LARSON RIVER ROAD AUTO STORAGE

Project Title:
LARSON RIVER ROAD STORAGE

Issue Set & Date:
PERMIT SET
07/28/2023

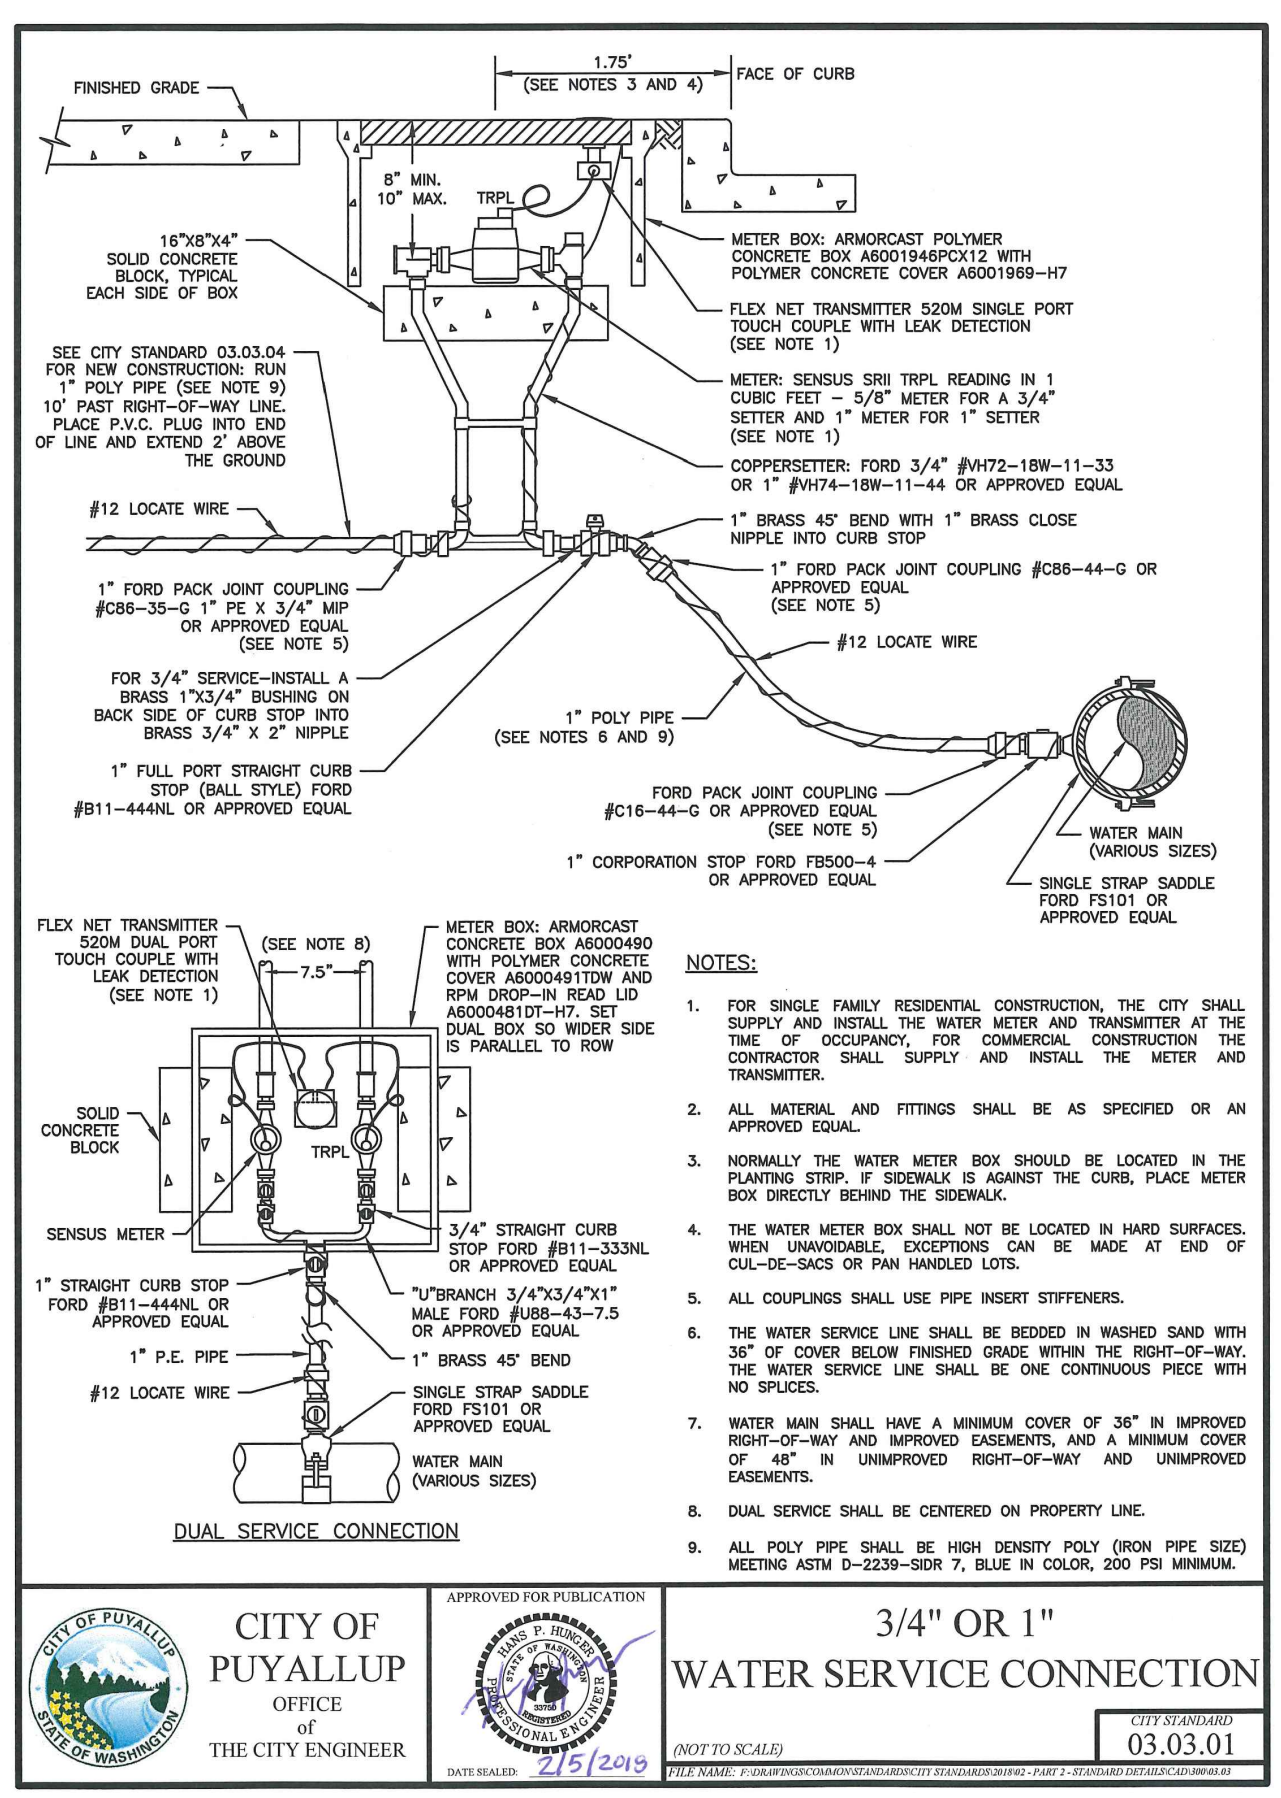
Civil Sheet C2.1: This revised plan does not have a proposed fire hydrant. Remove Keynotes 6 and 7.

Civil Sheet C2.1: In this revised plan there is not a driveway approach that interferes with the existing dual water service on River Rd. These dual water meters do not need to be relocated to back of sidewalk, but they must be up to grade meeting City standard requirements and placed out of a hard surface. Note 9 can be removed.

Civil Sheet C2.1: Keynote 11 calls for relocating a water service that has been removed from the water main on 15th St NW. Please note that the east dual water service on River Rd can be used for irrigation, so a water service on 15th St NW is not needed.

Civil Sheet C2.1: A DCVA must be installed behind the sidewalk for the domestic water service to the west and for the irrigation service to the east. Clearly show this on the plans.

Access to this building seems limited. Provide walkway or parking configuration that tends to pedestrian access of building. [Sheet C2.1, 20230727-LARSON RIVER ROAD STORAGE CIVIL PLANS-2160102-RESUBMITTAL]
